**SITE PLAN REVIEW COMMITTEE
MEETING AGENDA**

DATE: Thursday, December 14, 2017
TIME: 7:00 – 10:00 p.m.
PLACE: 2100 Clarendon Boulevard, **Room 311**
Arlington, VA 22201

Item 1. Crystal Square North Retail (SP #90) 7:00 – 9:00 p.m.
(RPC # 34-020-248 through -251, 34-020-037, and 34-026-033)
Planning Commission and County Board meetings TBD.
Peter Schulz (CPHD Staff)

ITEM 1
Crystal Square North Retail
(SP #90)

**EXISTING AND PROPOSED BUILDING
CONSTRUCTION TYPES KEY PLAN**

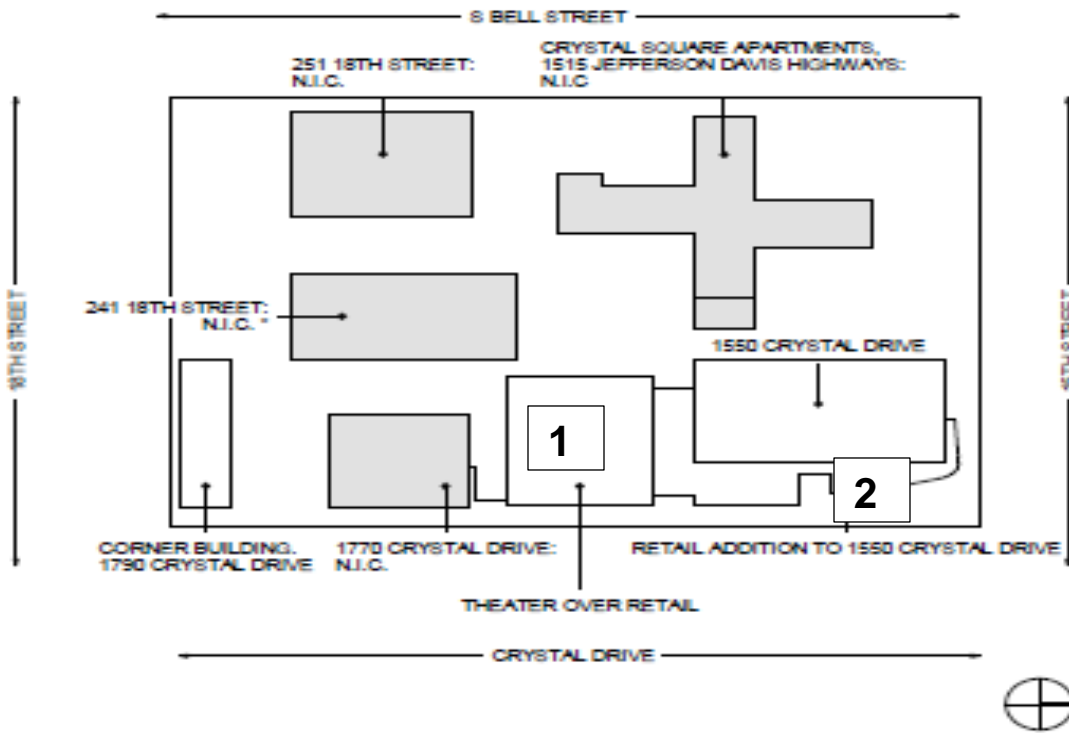
Above the first level of the movie theater, glass is replaced with a decorative metal screen at the mezzanine level (additional detail of which will be needed), and gray panels on the second level. A translucent feature stretching upward two (two) stories breaks the plainness of the upper stories.

The third level of the theater is set back from the lower levels, presents a plain gray wall to Crystal Drive. The developer’s plans state “potential art” and additional information will be needed on the visibility of this wall from public rights-of-way.
